SERVICE BULLETIN

N° 139-543

DATE: February 3, 2021

ATA 71 – TUNNEL ASSY AND FIREWALLS RETROMOD

Figure 1

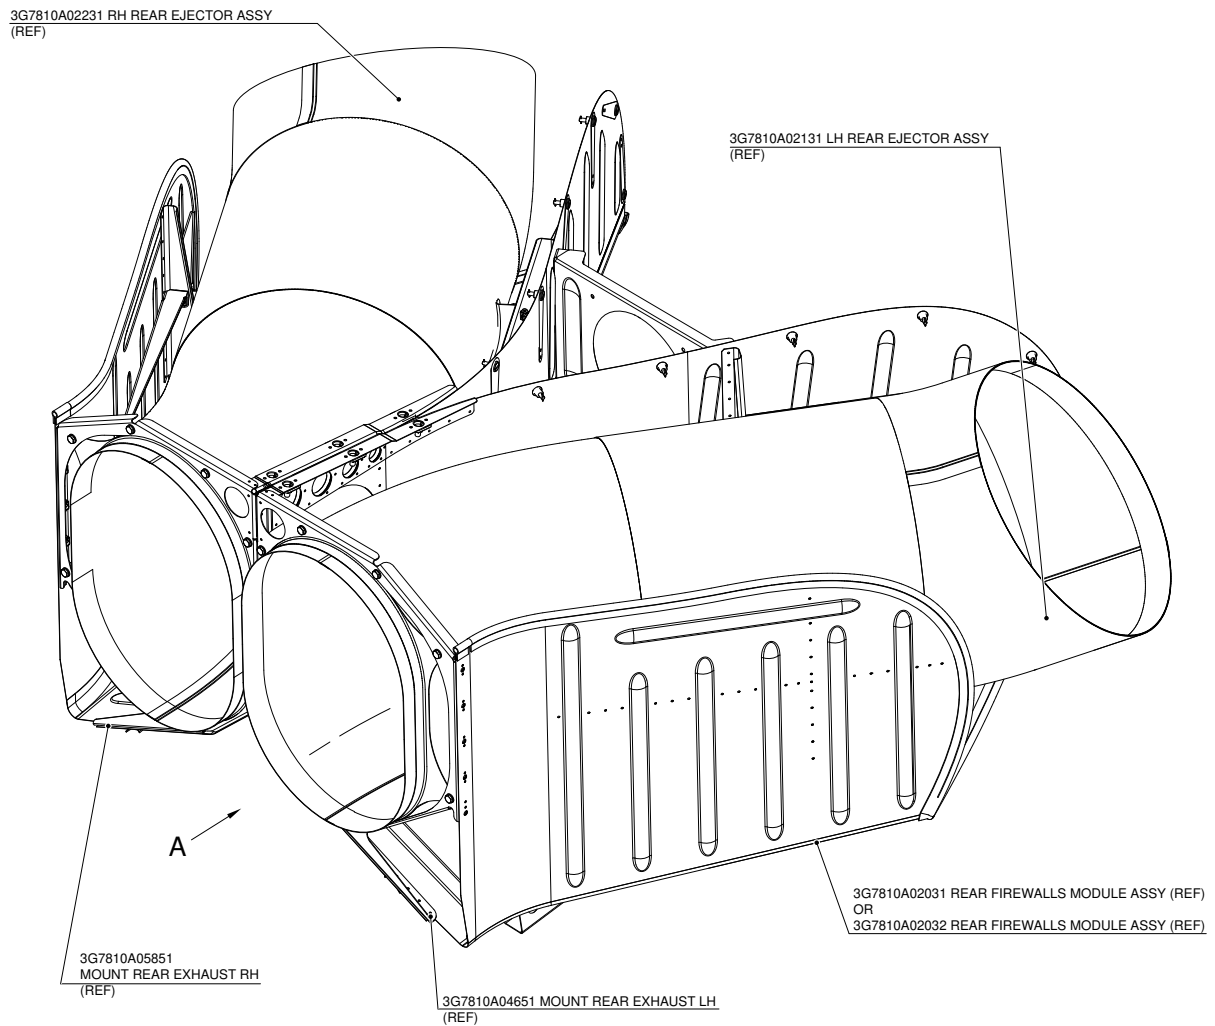
1. In accordance with AMP DM 39-A-00-20-00-00A-120A-A, prepare the helicopter on ground for a safe maintenance. Disconnect the battery, all electrical power sources and/or the external power supply.
2. In accordance with AMP DM 39-C-78-10-01-00A-520A-A and with reference to Figure 1, remove the rear exhaust module from the helicopter. Retain the fixing hardware for later reuse.
3. In accordance with AMP DM 39-C-78-10-01-01A-520A-B and with reference to Figure 1, remove the LH rear ejector assy P/N 3G7810A02131 and RH rear ejector assy P/N 3G7810A02231 from the rear exhaust module. Retain the fixing hardware for later reuse.

4. With reference to Figures 1 thru 5, perform the rear exhaust module retro modification P/N 3G7810P01331 as described in the following procedure:
 - 4.1 With reference to Figure 1 and Figure 3 View E, temporarily locate the stiffener LH reworked P/N 3G7810P01551 and the stiffener RH reworked P/N 3G7810P01651 coordinating with existing holes on the mount rear exhausts LH P/N 3G7810A04651 and RH P/N 3G7810A05851. Countermark the positions of n°34 rivet holes on related mount rear exhausts.

Figure 2

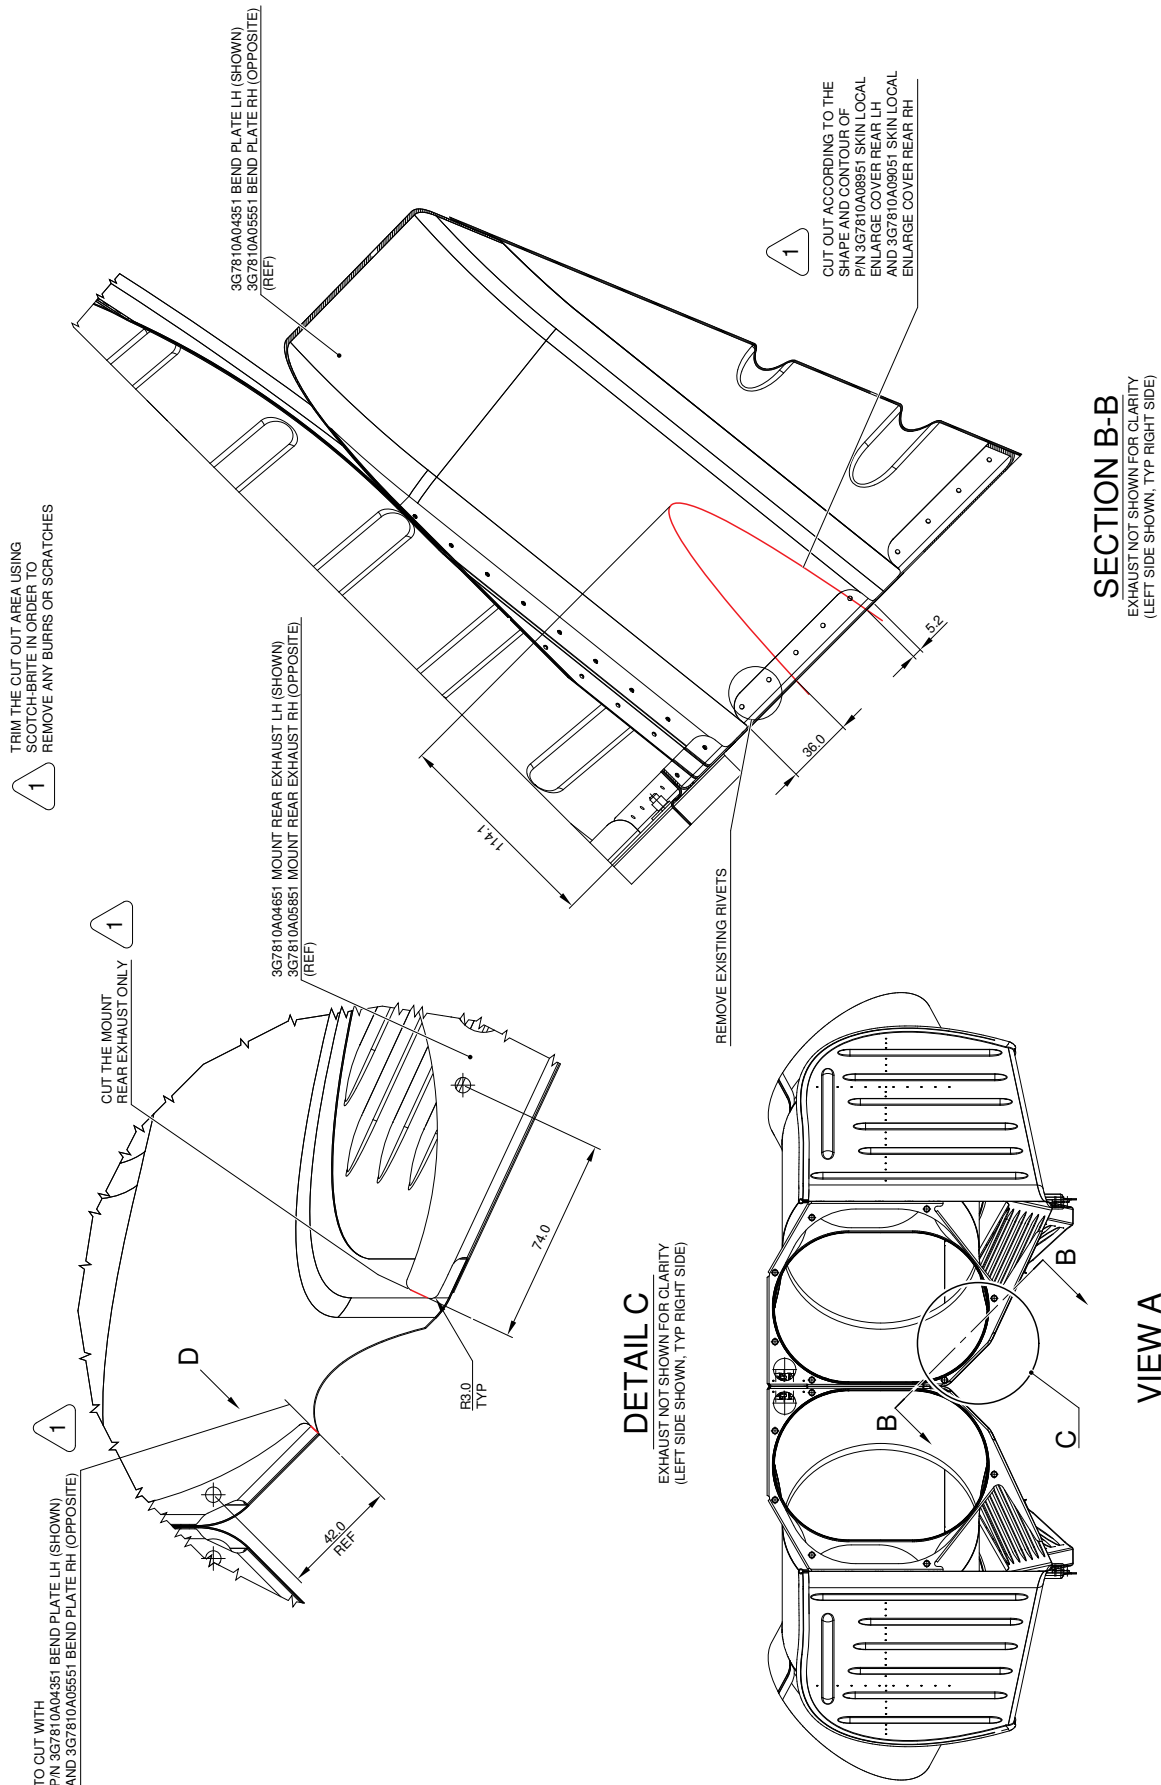
- 4.2 With reference to Figure 2 Detail C, perform the indicated cut-outs of the mount rear exhaust LH P/N 3G7810A04651 and of the mount rear exhaust RH P/N 3G7810A05851 coordinating with stiffener LH reworked P/N 3G7810P01551 and stiffener RH reworked P/N 3G7810P01651.

- 4.3 With reference to Figure 2 Section B-B, perform the indicated cut-outs on bend plate LH P/N 3G7810A04351 and RH P/N 3G7810A05551 coordinating with skin local enlarge cover rear LH P/N 3G7810A08951 and RH P/N 3G7810A09051. If necessary, use Figure 5 to perform the cut, coordinating with mount rear exhaust existing holes.

- 4.4 With reference to Figure 2 Section B-B, drill out the indicated existing rivets.
- 4.5 With reference to Figure 3 View E and Figure 4 Section F-F and Section G-G, install stiffener LH reworked P/N 3G7810P01551 by means of n°6 rivets P/N MS20615-3M3R and n°11 rivets P/N NAS1200M3-4 on mount rear LH.

Figure 4

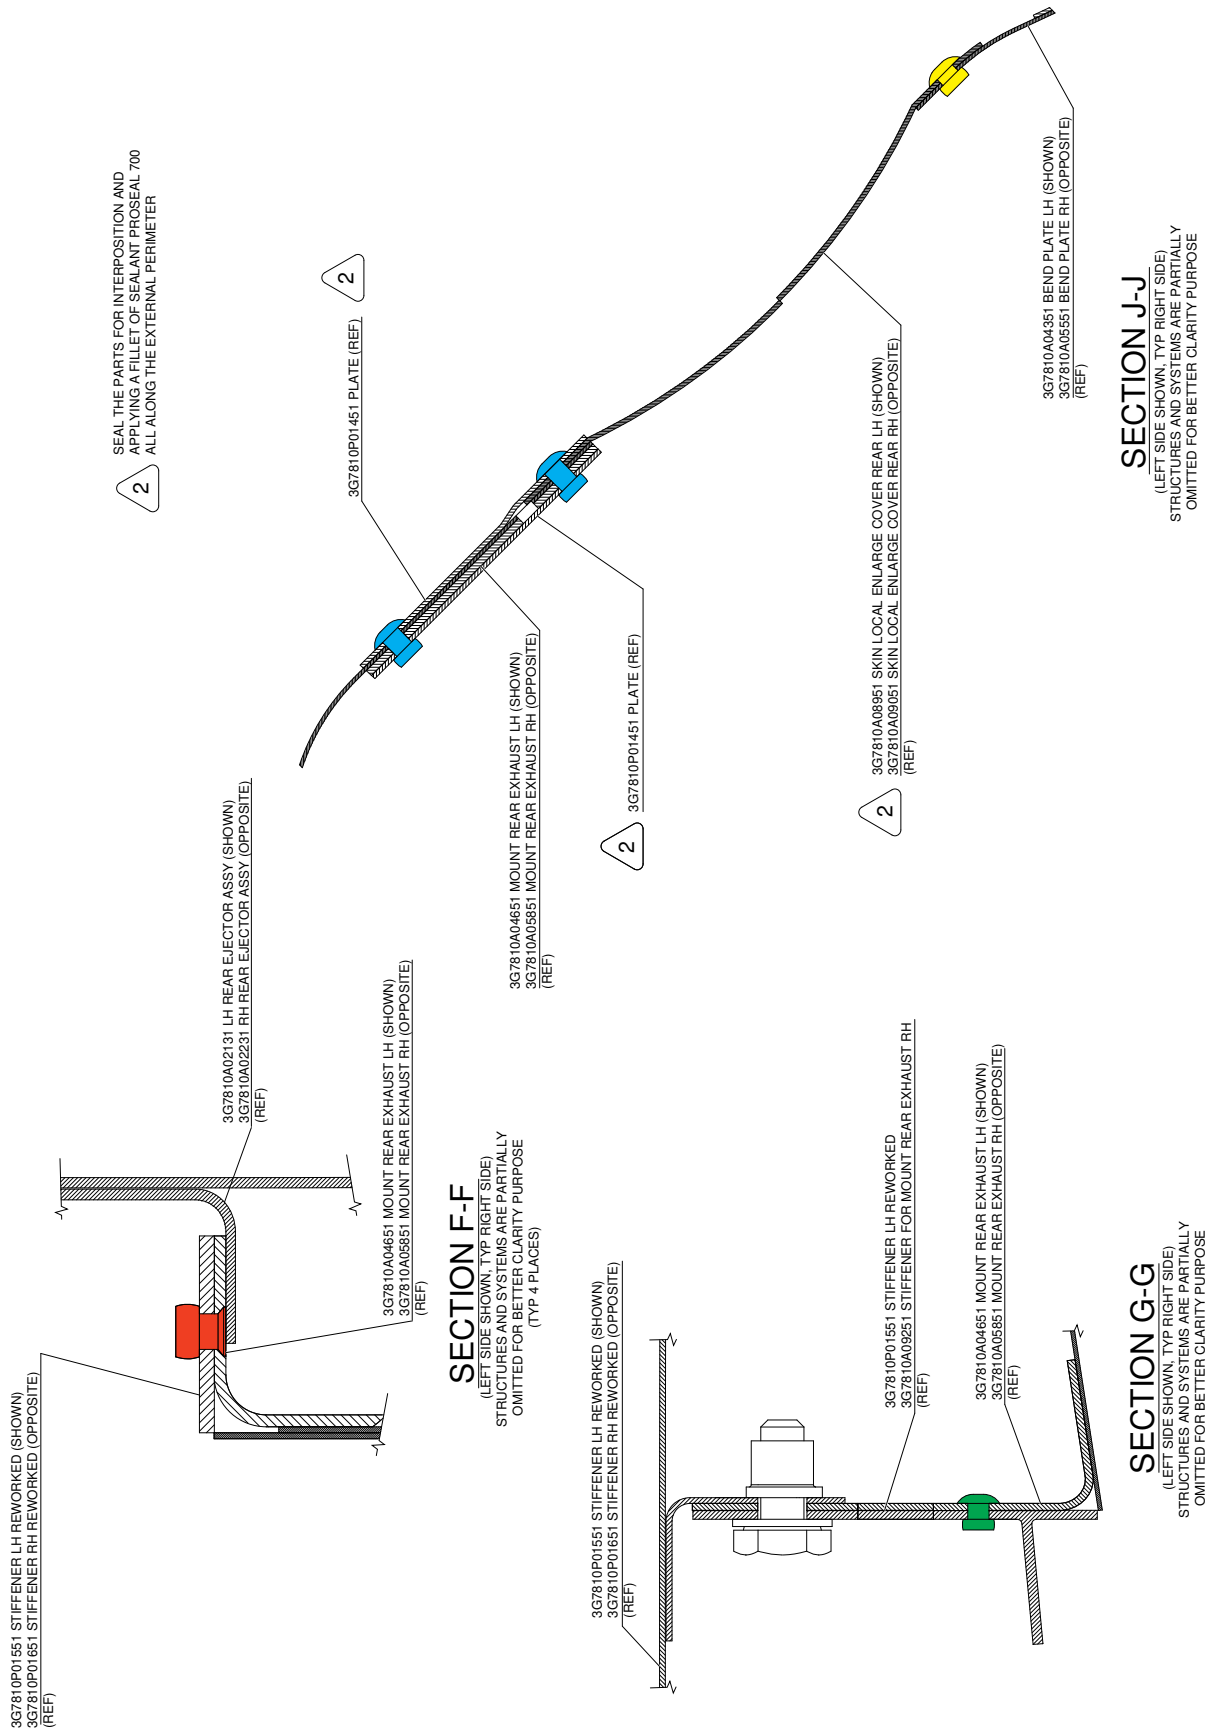
- 4.6 With reference to Figure 3 View E and Figure 4 Section F-F and Section G-G, install stiffener RH reworked P/N 3G7810P01651 by means of n°6 rivets P/N MS20615-3M3R and n°11 rivets P/N NAS1200M3-4 on mount rear RH.

- 4.7 With reference to Figure 3 View D and View H and Figure 4 Section J-J, temporarily locate the skin local enlarge cover rear LH P/N 3G7810A08951 and RH P/N 3G7810A09051 and the n°4 plates P/N 3G7810P01451. Countermark the positions of n°26 rivet holes of the skin local enlarge covers on bend plates.

- 4.8 With reference to Figure 3 View H and Figure 4 Section J-J, install skin local enlarge cover rear LH P/N 3G7810A08951 and RH P/N 3G7810A09051 and the n°4 plates P/N 3G7810P01451 by means of n°22 rivets P/N MS20615-3M3 and n°4 rivets P/N MS20615-3M4.
- 4.9 With reference to Figure 4 Section J-J, seal all around the edges of the skin local enlarge cover rear LH P/N 3G7810A08951 and RH P/N 3G7810A09051 and the n°4 plates P/N 3G7810P01451 by means of sealant Proseal 700 (C032).
5. With reference to Figure 1, remark the reworked rear exhaust module as P/N 3G7810P01331.
6. In accordance with weight and balance changes, update the Chart A (see Rotorcraft Flight Manual, Part II, section 6).
7. Return the helicopter to flight configuration and record for compliance with Part I of this Service Bulletin on the helicopter logbook.
8. Send the attached compliance form to the following mail box:

Figure 6

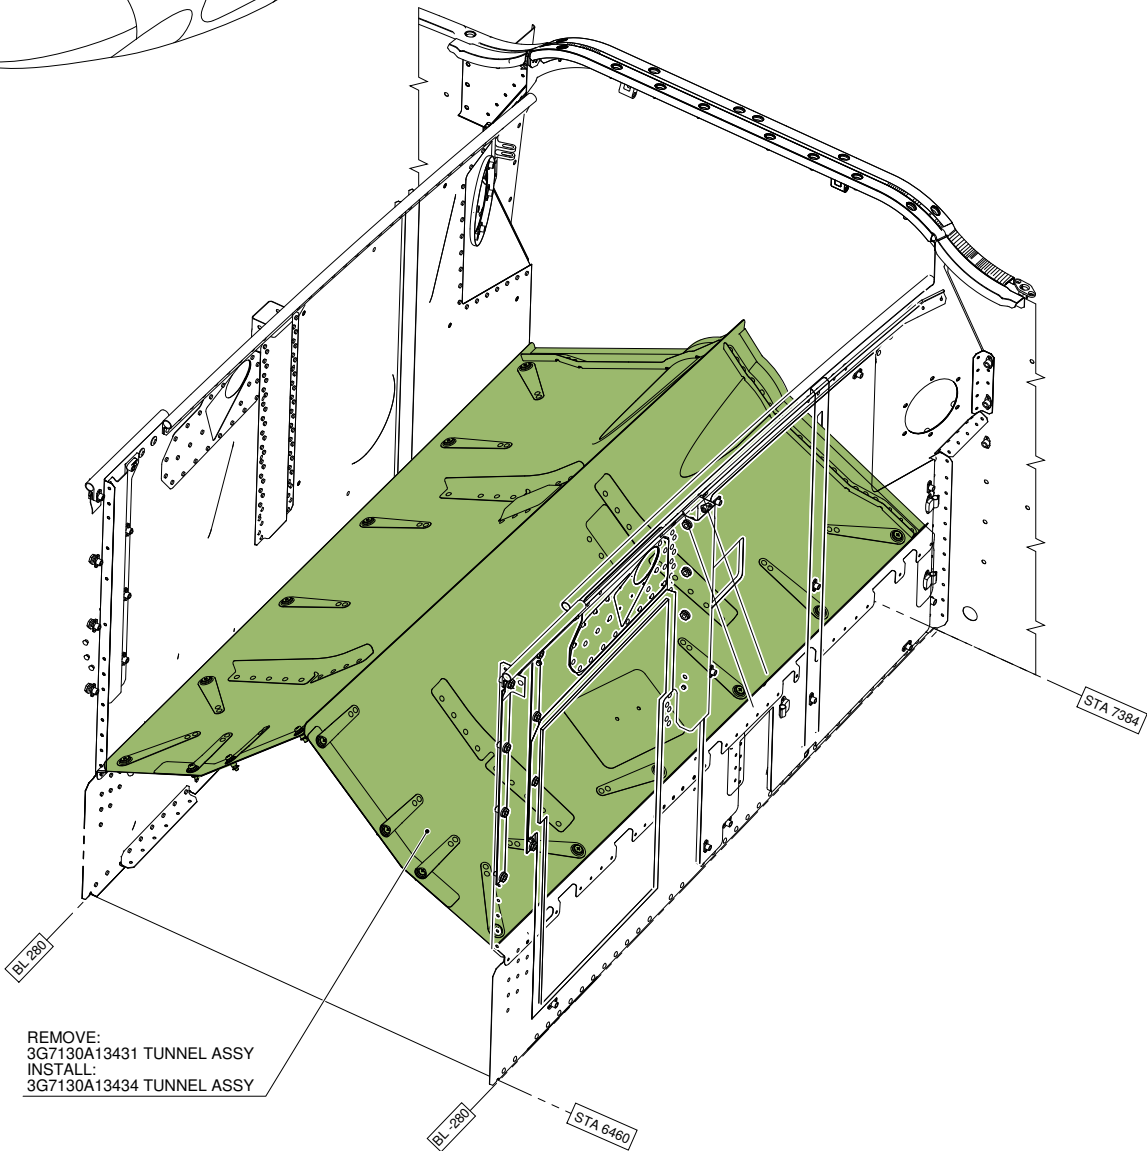
7. With reference to Figure 6, remove and discard the tunnel assy P/N 3G7130A13431 from the helicopter, unlocking the related turn locks.
8. With reference to Figure 8, remove and discard n°12 anchor nuts P/N A242ARD.

Figure 7

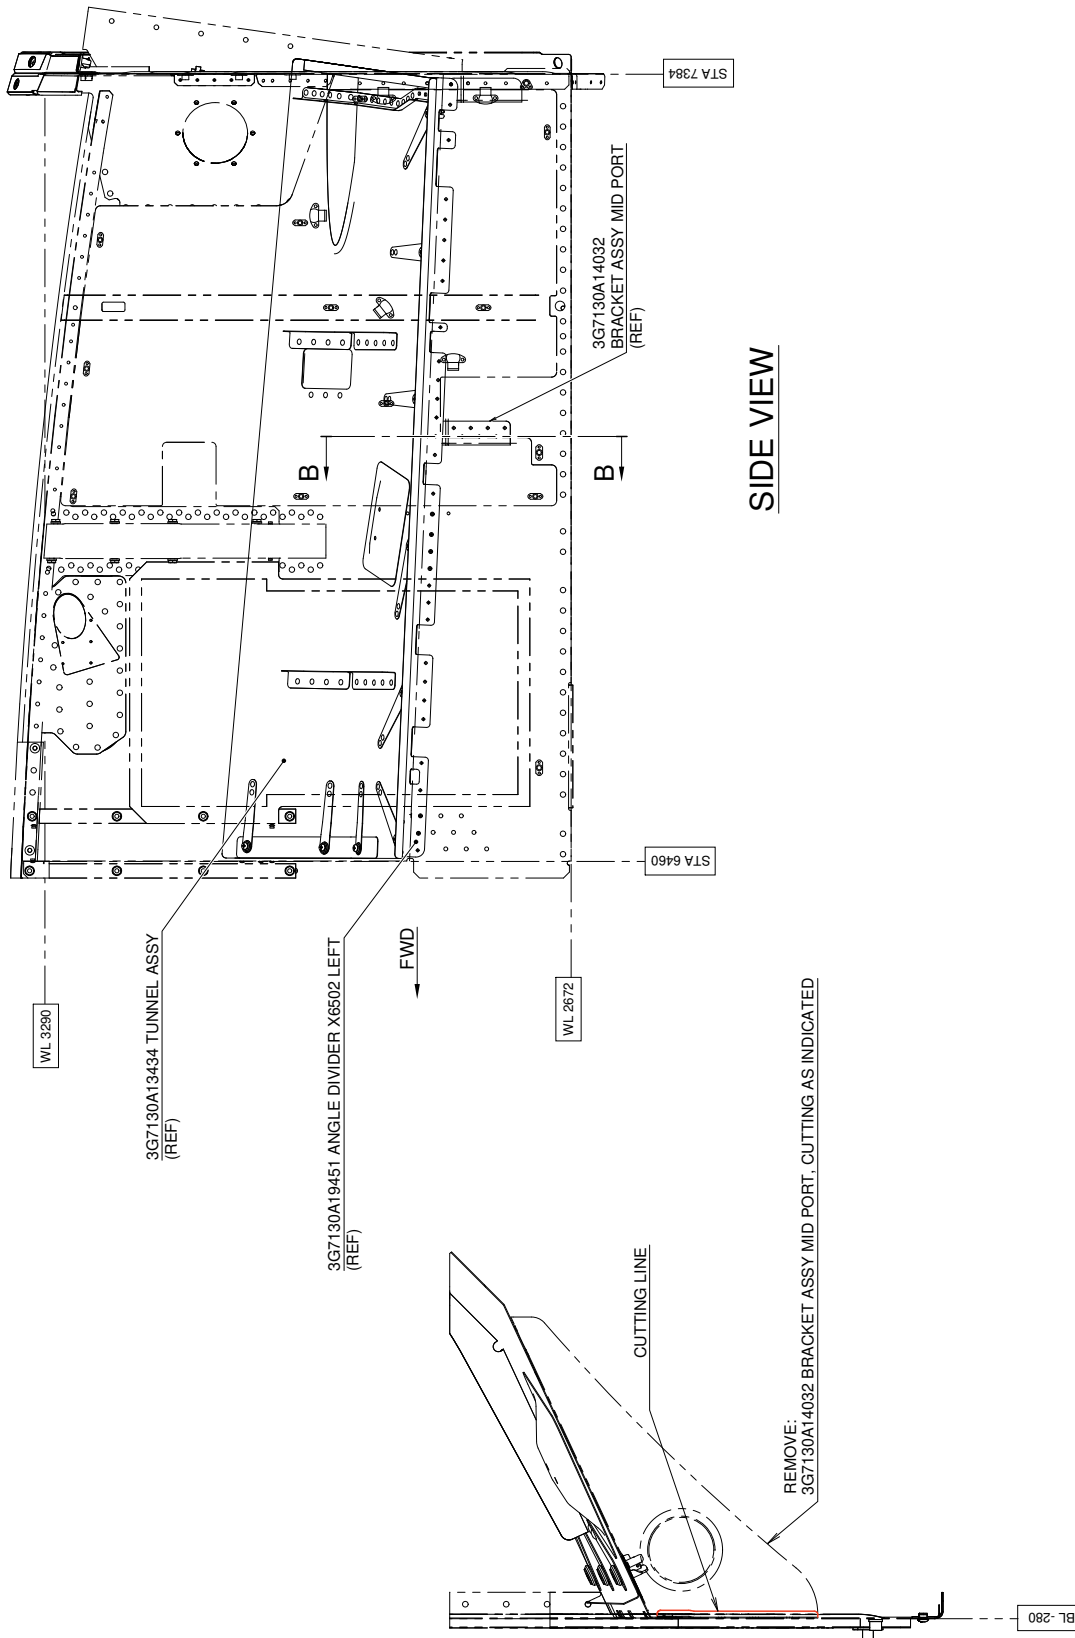
9. With reference to Figure 6 Section B-B, cut along cutting line shown to remove bracket assy mid port 3G7130A14032.
10. Repeat step 9 to remove bracket assy aft port P/N 3G7130A14231, bracket assy P/N 3G7130A14132 and bracket assy aft stbd P/N 3G7310A14331.
11. With reference to Figure 8, install plate LH assy P/N 3G7130A36331 and plate RH assy P/N 3G7130A36431 by means of n°80 rivets P/N NAS1200-3-4.
12. With reference to Figure 6, install tunnel assy P/N 3G7130A13434 by means of related turn locks.
13. With reference to Figures 9 and 10, check the clearances between tunnel assy and tail rotor drive as described in the following procedure:
